From: Derek Albertson
Sent: Thursday, January 18, 2024 1:20 PM
To: Meredith Badalucca
Subject: 245 Route 32; proposed residential development
Attachments: 245 rte 32 ProposedCondoDevelopment_Wright_Pierce-Cross-Check 9-26-2023_Optimized (1).pdf

RE: Condition of Approval Response
22 Unit Condominium
245 Route 32
Uncasville, Connecticut

PROPOSED 22 UNIT CONDOMINIUM DEVELOPMENT

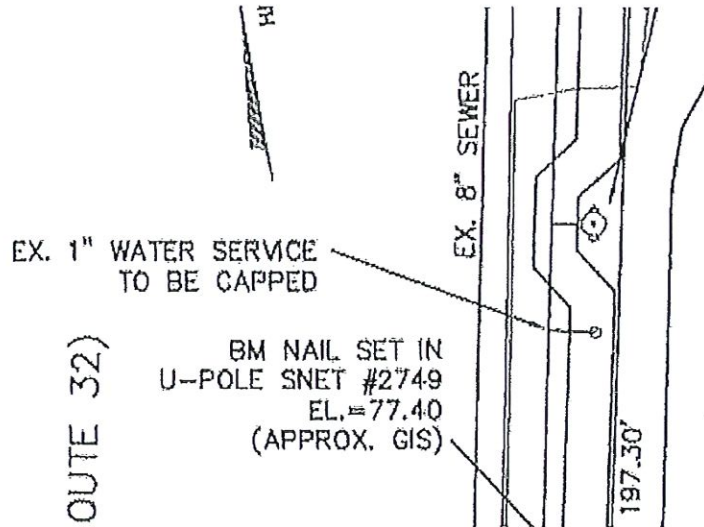
3. Discrepancy between 6" or 8" Dia. Size Sanitary Sewer in street.
Response: Reference to "Grading, Drainage, & Utility Plan for Commercial/ Residential Complex Norwich-New London Road (CT Route 32) Montville, Connecticut Prepared for Tomashe LLC 19

Appears in line with Montville WPCA guidelines. Confirm with Derek and Jon.

Tulsa Court Monmouth Junction, NJ 08852. By Development Solutions, LLC Dated September 19, 2014, Revised through 3/17/15". Said drawing was used as the base and depicts the Sewer Lateral to be 6" service, but the Sanitary Main north of the San. MH (where this development will tie in) lists the Existing Sanitary Sewer as 8" Service. See Cut Out Attachment:

Response Con't: As a safety factor, and provided for confidence in not overwhelming the existing Sanitary Sewers' capacity, @ 8"Ø QAllow= 0.856 cfs, @ 6"Ø, Calculated QAllow= 0.397 cfs Using the same slope and material, which are both > the proposed Q (flow) going into the System from the 22 units including Stormwater infiltration which was calculated as 0.054 cfs. Therefore, either 6" or 8" size main will suffice. This writer agrees that the Existing Sanitary Sewer service should be verified to avoid any future confusion or conflict.

Sheet Number: C-2.1

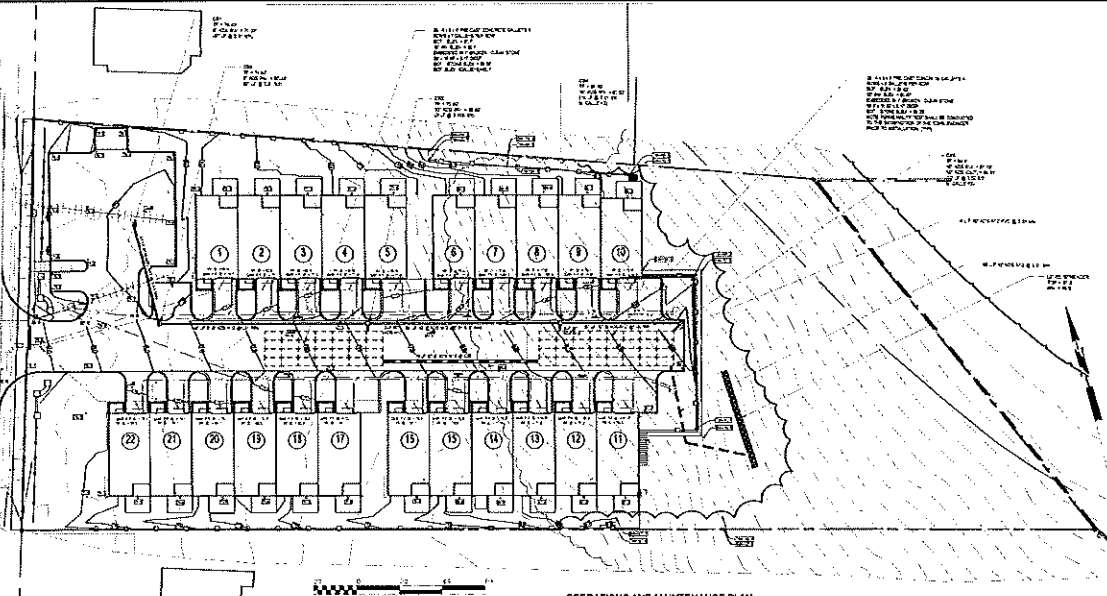
2. Sheet C-2.1 – Revise sheet to identify space in front of garage as 1 parking space.

11. ZR Sec. 19 (Signs) – Proposed complex sign on the face of the decorative wall requires review & approval of its size by the Zoning Official (zoning permit). Condition of Approval.

Response: All spaces in front of the garages now indicate one(1) car inside and one (1) car outside.

Response: Acknowledged – The note referring the sign on Sheet C-2.1 has been modified to indicate such approval is required.

Sheet Number: C-31

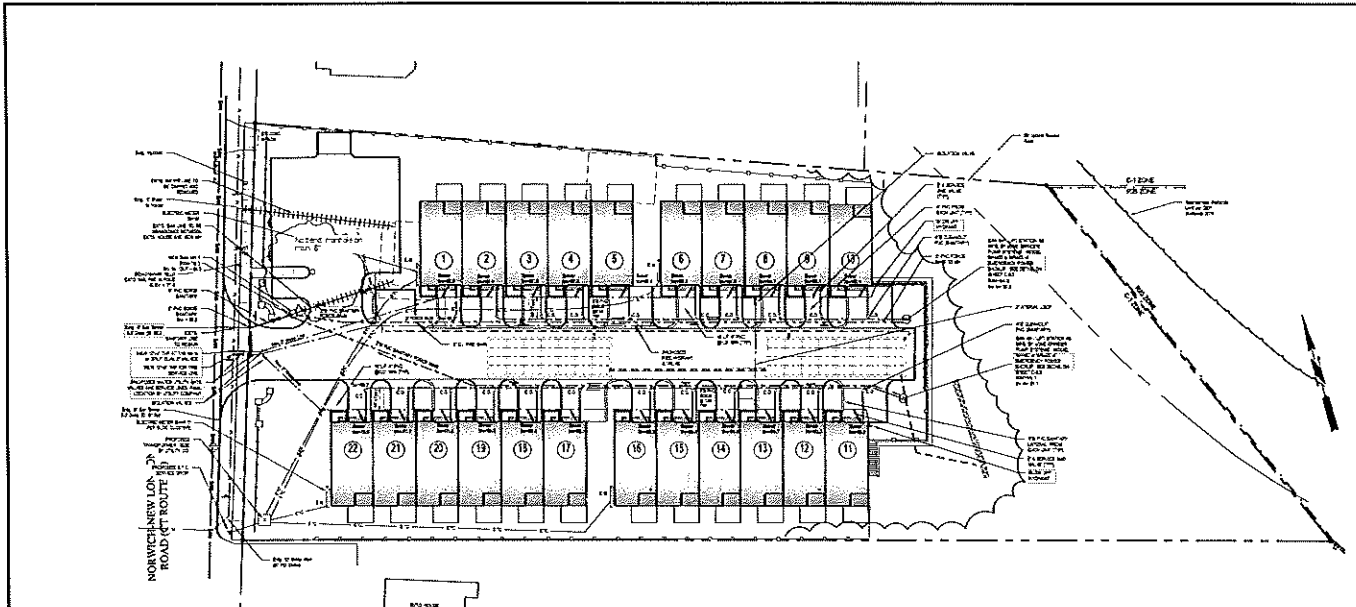
3. Sheet C-3.1 – Note 4 – Add zoning dept. & fire marshal's office.

4. Permeability testing per CT DEEP recommendations must be performed in the proposed subsurface drainage areas once the filling is completed. The Town must be provided with the data prior to the installation of the subsurface galley system

Response: The note has been revised on Sheet C-3.1 and added to the detail on Sheet C-6.1.
6. The plans must be revised to read Schedule 80 PVC as appropriate.

Response: Note 4 has been revised to add "zoning department, and fire marshal's office"

Response: Acknowledged. A note has been added to Sheet C-3.1 indicating the permeability testing requirement.
5. The note added to the plans on Sheet C-3.1 regarding a CT Licensed Engineer designing and inspecting the block wall installation must be added to the wall detail, also the note must delete the Town Engineer and add Town Building Inspector.

Response: Sheet C-3.1 has been revised to indicate Sch 80 PVC pipes where specified.
7. A detail of the level spreader must be added to the plans. The plunge pool detail must be deleted.

Sheet Number: C-32

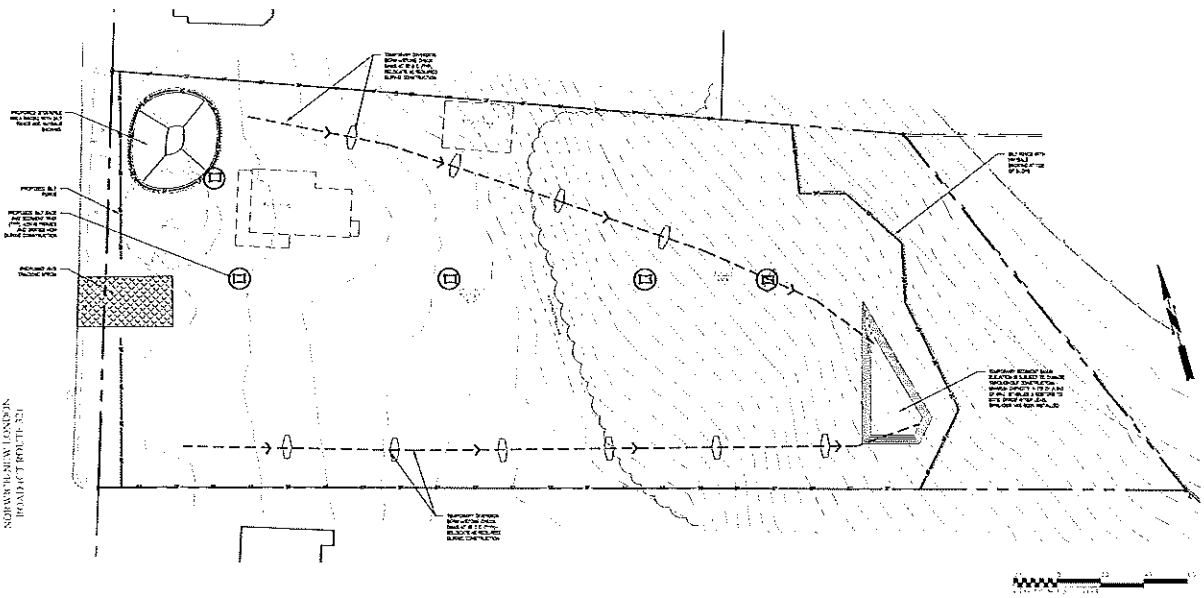
- There is a none on Sheet C3.2 that calls out San MH Lift Station,
Response: The callout has been removed.

- The pipe material for the 2" force main does not appear to be labeled.
Response: 2"Ø PVC label was added to the Utility Plan Sheet C3.2. e-One recommends the use of HDPE 11 pipe for force main piping.

- Call out the 12" X 6" Tap for the Fire Service main as well.

- The 6" fire service line also needs to have valving shown.

- C-3.2 drawing indicates an erroneous notation for a pump station.

- Recommend the configuration from 12-inch water supply main to 4-inch pipe then two 2-inch supply lines rather than what is depicted.

Response: Call out was added to Plan on Sheet C 3.2 "New 12" X 6" Tap for Fire Service line.

Response: Valving was added to 6" Fire Service Line.

Response: Erroneous note has been removed.

Response: The above change has been incorporated into the design. Refer to Utility Plan Sheet C-3.2.

Scale: 1" = 20'
 Sheet Number: C-41

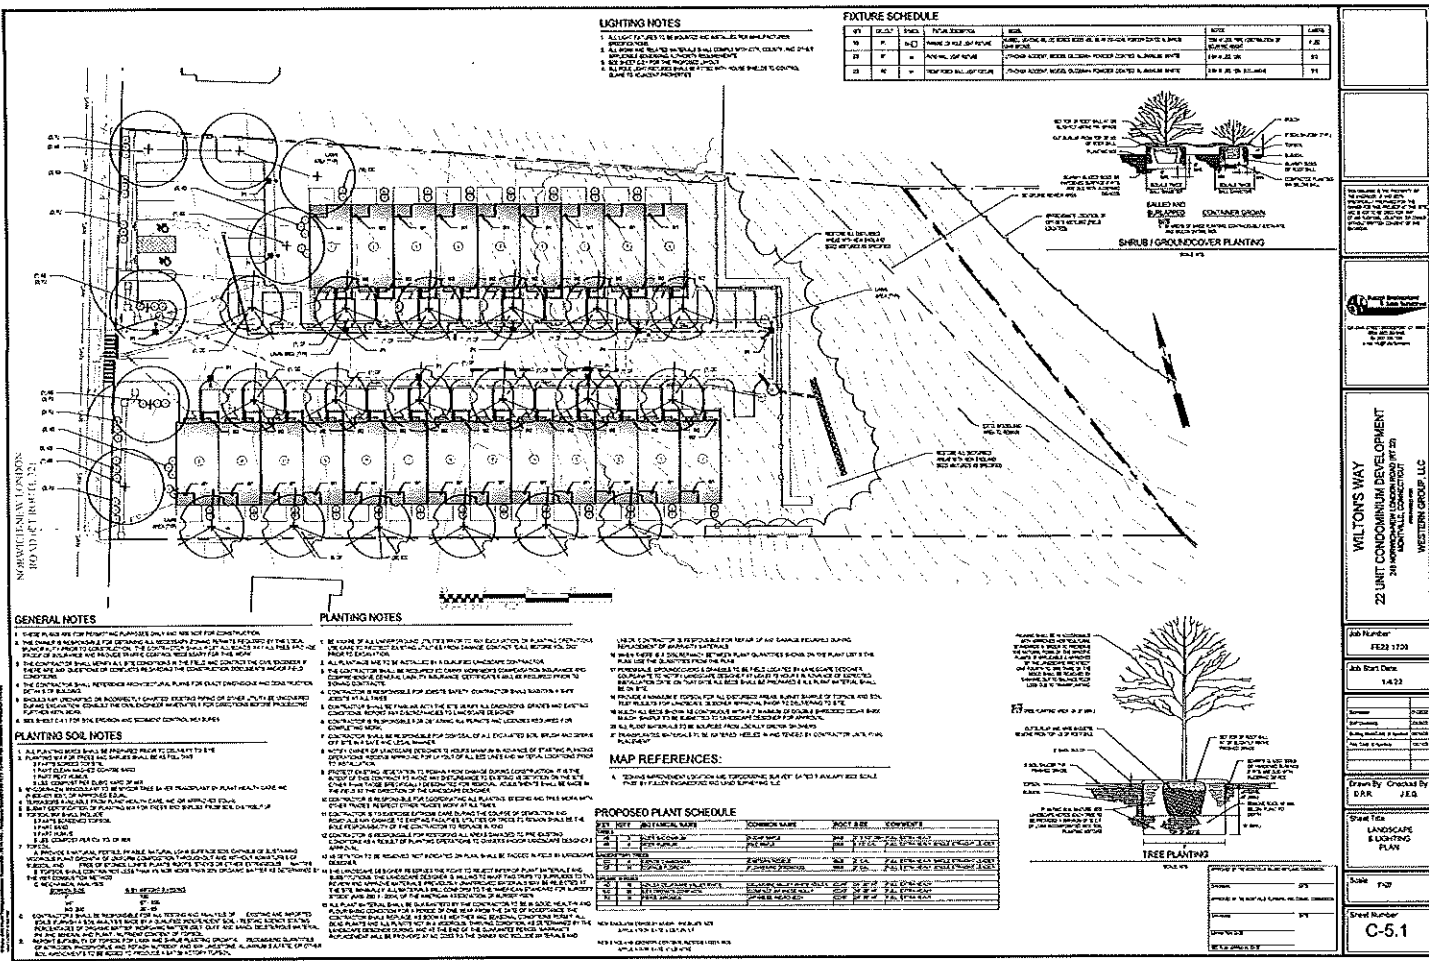
6. Sheet C-4.1 (E&S Control Plan) – Any future construction staging areas (office trailer, laydown, etc.) shall require review and approval by the Zoning Official or Planning Director. Condition of Approval.

Response: Note 7 has been added to Sheet C-4.1 indicating the above Condition of Approval.
7. Sheet C-5.1 – Revise title to "Landscape & Lighting Plan." Cond. Of Approval.
